DESIGN, ACCESS AND HERITAGE STATEMENT

Additional Window Reinstatement Works to
the Main Hall

ADDENDUM 1 – GW.14

Walton Hall, Walton-on-Trent

Figure 1 Landing of staircase with timber wall panelling, infilled GW.14 located behind.

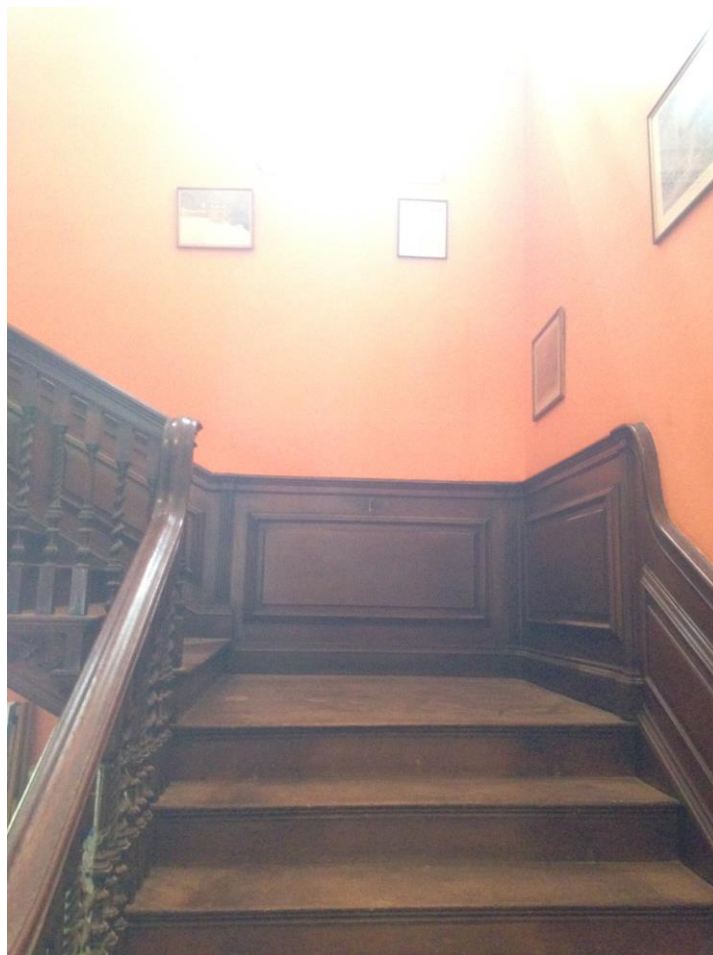
The previous proposals were for the window to be reinstated with a 9-over-9 sash, shutters and architrave, detailed to match the other ground floor windows on the rear elevation. It was proposed to keep the existing panelling to the staircase and replicate this on the reverse side.

This proposal results in the internal structure and boarding (in this case the staircase and panelling) clashing with the position of the window so that the internal panelling can be seen directly behind the window.

To improve upon the visual effect of retaining the staircase landing behind the re-instated window GW.14 it is now proposed that a section of the wall panelling that will be in front of the newly reinstated window, is to be removed and in its place new spindles installed with handrail above. The top rail of the panelling has the same profile as the handrail on the opposite side of the staircase so a new handrail formed to match the existing can be positioned to run as a continuation of the top rail. Below this the spindles will be modelled on the existing spindles of the staircase, being in a repeated group of 3. This will allow more light through the reinstated window and lessen the effect of the structure behind the glazing when viewed externally. The design will allow the new additions of the balustrade to read as a coherent part of the staircase landing.

We intend to reuse the removed historic panelling within the hall. The wall panelling that is to be removed and be re-used within the kitchen (room G.13) where there is an area of timber panelling missing where a sink is currently installed. The removal of the kitchen has been agreed in the previous listed building consent, there is a condition requesting

Figure 2 Existing window FW.15 (6-over 6 sash) with architrave obscuring top lights.

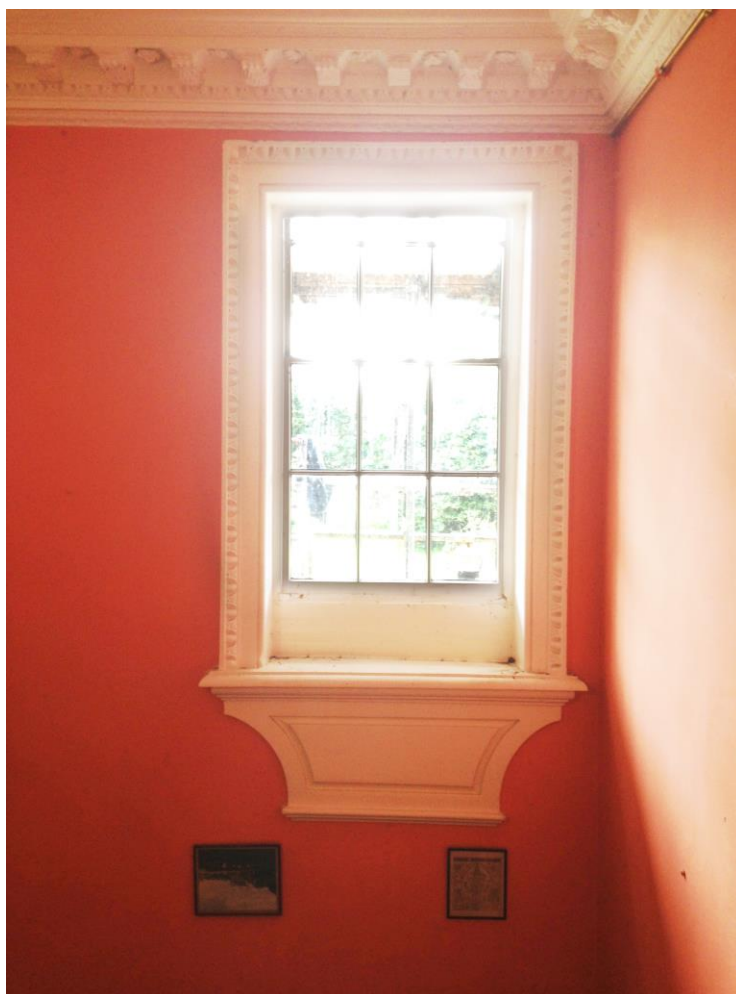
As discussed with the Heritage Officer, there is precedent at Walton Hall for the formal external appearance of the windows not to be followed through when viewed internally. The 2 no. windows directly above window GW.14 both have surrounds internally that do not marry up to the external window openings; the architrave and soffit obscures the majority of the top lights. In effect the 6-over 6 sash visible externally is viewed as a 3-over-6 sash internally.
